ANGUS COUNCIL

DEVELOPMENT MANAGEMENT REVIEW COMMITTEE – 4 SEPTEMBER 2023

SMUGGLERS TAVERN, 65 LADYBRIDGE STREET, ARBROATH

**PROPOSAL & ADDRESS – CHANGE OF USE FROM PUBLIC HOUSE TO FLAT AND
DORMER EXTENSION TO ATTIC OF EXISTING FLAT AT SMUGGLERS TAVERN 65
LADYBRIDGE STREET ARBROATH**

proposed east elevation

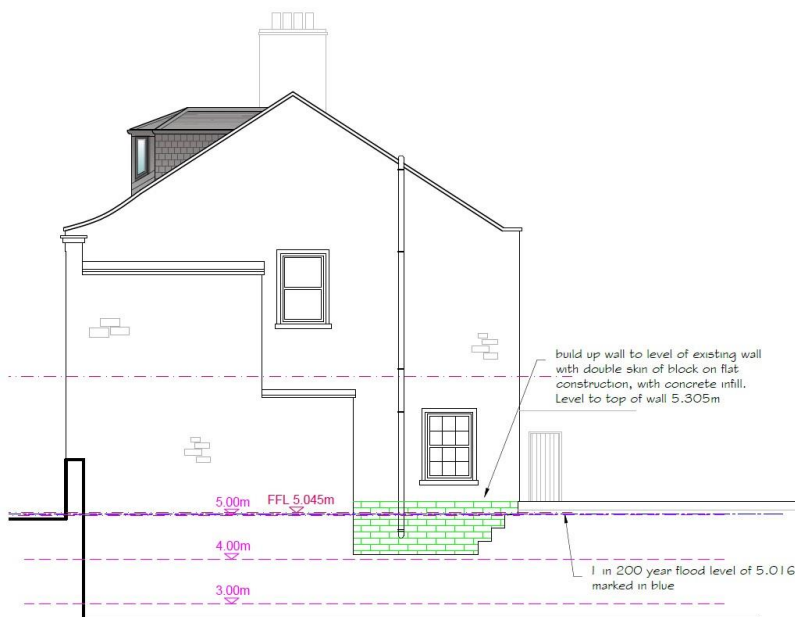
SEPA had commented on the gable wall being a point of erosion and there being a risk of scour. We looked at this detail where the water line would be above this 90-degree check in the wall, and we put forward proposals to build up this wall to allow the water to flow smoothly past. This is a detail we are surprised the flood prevention scheme had no issues with but was picked up in this application. Therefore, we shall be building up this wall if the application is approved to prevent any damage should the water ever rise to this point.
